**PLANNED UNIT DEVELOPMENT
& SUBDIVISION STAFF REPORT****Date: March 4, 2010****DEVELOPMENT NAME**

Greater Vision of Faith

Greater Vision of Faith Subdivision

LOCATION461 & 463 Bay Shore Avenue
(Southwest corner of Bay Shore Avenue and Josephine Street)**CITY COUNCIL
DISTRICT**

SITE PLAN

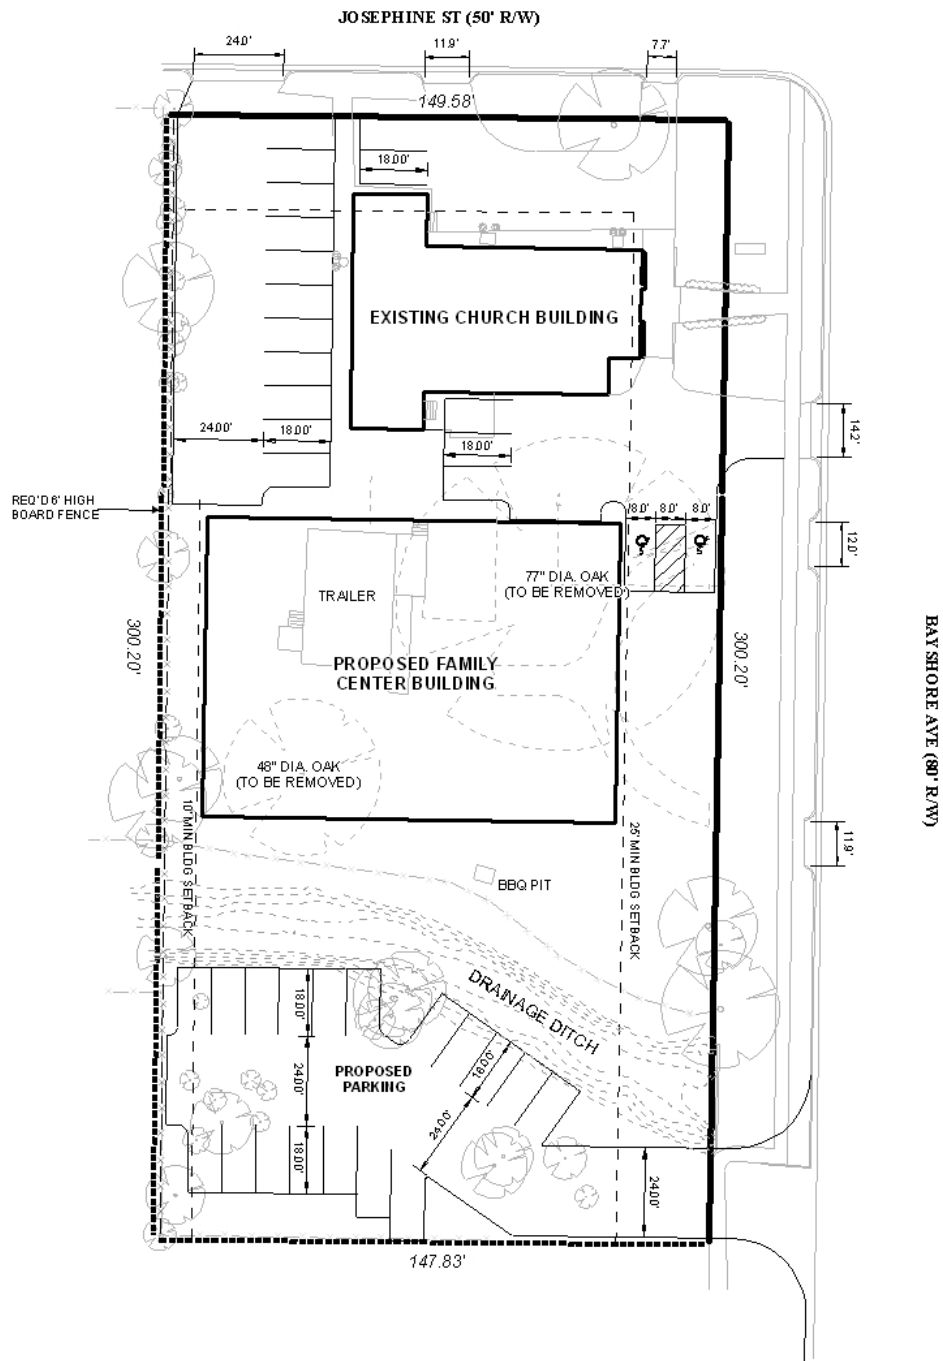
A drainage easement will be required on each side of the creek; the width of the easement shall be a minimum of 50' wide and its location to be coordinated with City Engineering Department. The parking lot on the south side of the creek shall not extend beyond the existing top of bank without approval from the City Engineer. A note shall be added to the plat stating that any pavement or other structure located within the drainage easement is subject to removal without compensation for the purposes of maintenance of the creek and any cost associated with the replacement of such shall be the sole responsibility of the property owner. Must comply with all storm water and flood control ordinances. Any work performed in the right of way will require a right of way permit. Any existing damaged sidewalk panels and/or driveway aprons shall be replaced.

Driveway number, size, location, and design to be approved by Traffic Engineering and conform to AASHTO standards. The northern most drive accessing Bayshore Avenue must be widened to the standard of twenty-four feet with twenty foot radii. The unused driveway cuts to Bayshore Avenue must be removed. Limited to one curb cut to Josephine Street.

There is a 48-inch Live Oak tree and a 77-inch Live Oak tree on the site that are proposed to be removed. After consultation with the applicant's Engineer, relocation of proposed building to save the trees is not possible due to existing open ditch on the site.

Both City Engineering and City Traffic Engineering have expressed concern with the site plan. Regarding City Engineering's concerns, the site does not appear to depict any retention or detention for the site. Additionally, there is a large drainage ditch cutting across the property, with a new parking lot encroaching into that ditch. The applicant should consult with City Engineering to determine the requirements and make appropriate changes.

City Traffic Engineering states that only one curb cut should be allowed to Josephine Street. The applicant currently illustrates three curb cuts, with only one being of standard width.

Additionally, the site plan depicts asphalt parking and maneuvering area within the Josephine Street right-of-way, and this should be removed. Along Bayshore Avenue, the two unused driveway cuts should be removed, and the northernmost curb cut should be revised to meet the standard 24-foot width.

- 3) consultation and possible revision of the site plan to comply with Engineering Requirements *“A drainage easement will be required on each side of the creek; the width of the easement shall be a minimum of 50’ wide and its location to be coordinated with City Engineering Department. The parking lot on the south side of the creek shall not extend beyond the existing top of bank without approval from the City Engineer. A note shall be added to the plat stating that any pavement or other structure located within the drainage easement is subject to removal without compensation for the purposes of maintenance of the creek and any cost associated with the replacement of such shall be the sole responsibility of the property owner. Must comply with all storm water and flood control ordinances. Any work performed in the right of way will require a right of way permit. Any existing damaged sidewalk panels and/or driveway aprons shall be replaced”*;

- 4) revision of the site plan to comply with Traffic Engineering requirements *“Driveway number, size, location, and design to be approved by Traffic Engineering and conform to AASHTO standards. The northern most drive accessing Bayshore Avenue must be widened to the standard of twenty-four feet with twenty foot radii. The unused driveway cuts to Bayshore Avenue must be removed. Limited to one curb cut to Josephine Street”*; and

- 5) removal of any parking and/or maneuvering area from the right-of-way.
